Service Information Bulletin

SUBJECT	DATE
SPN 3361/FMI 5 (ACM) (GHG17) SPN 3361/FMI 5 (ACM) (GHG14)	January 2017

Additions, Revisions, or Updates

Table 1.

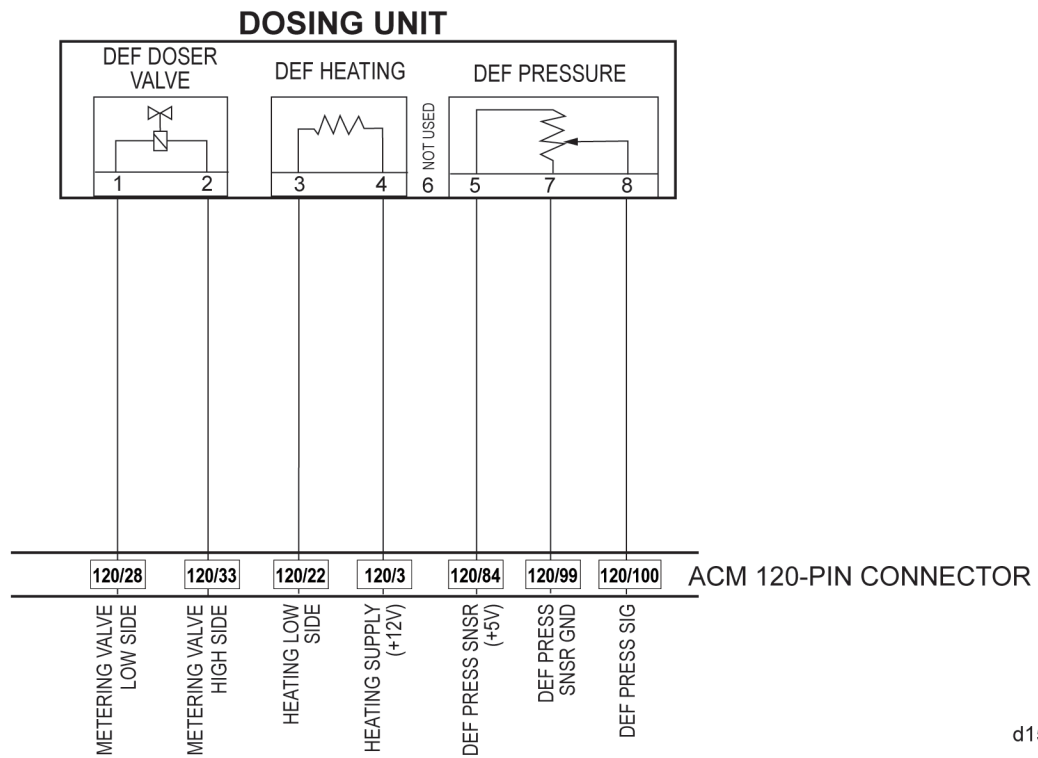
Publication Number / Title	Platform	Section Title	Change
DDC-SVC-MAN-0191	GHG17 Heavy Duty	SPN 3361/FMI 5 - GHG17	The diagnostic procedure has been updated. There is a new wiring graphic for the GHG17 since there is no intermediate vehicle harness on GHG17 models.
DDC-SVC-MAN-0084	GHG14 Heavy Duty	SPN 3361/FMI 5 - GHG14

1. Turn the ignition OFF.
2. Disconnect and inspect the DEF dosing unit electrical connector harness side. Is there corrosion present?
 - a. Yes; replace the DEF dosing unit and the aftertreatment harness. Refer to section "Removal of the Diesel Exhaust Fluid Dosing Unit". Verify repairs.
 - b. No; Go to step 3.
3. Are any of the pins or the connector damaged?
 - a. Yes; Go to step 4.
 - b. No; Go to step 5.

4. Inspect the DEF dosing unit electrical connector component side. Are any of the pins or the connector damaged?
 - a. Yes; replace the DEF dosing unit and the aftertreatment harness.
Refer to section "Removal of the Diesel Exhaust Fluid Dosing Unit"
Refer to section "Removal of the 1-BOX™ Aftertreatment Harness"
Verify repairs.

- b. No; replace the aftertreatment harness. Refer to section "Removal of the 1-BOX™ Aftertreatment Harness".
Verify repairs.
5. Use the appropriate flex probe and check pins 1 and 2 in the DEF dosing unit electrical connector harness side. Is either of the pins spread?

- a. Yes; replace the aftertreatment harness. Refer to section "Removal of the 1-BOX™ Aftertreatment Harness".
Verify repairs.
 - b. No; Go to step 6.
6. Jump pin 1 to pin 2 on the DEF dosing unit electrical connector harness side.

7. Connect DiagnosticLink®.
8. Turn the ignition ON (key ON, engine OFF).
9. Check the fault codes. Is fault code SPN 3361/FMI 5 now inactive and fault code SPN 3361/FMI 3 now active?

- a. Yes; replace the DEF dosing unit. Refer to section "Removal of the Diesel Exhaust Fluid Dosing Unit". Verify repairs.
 - b. No; replace the aftertreatment harness.
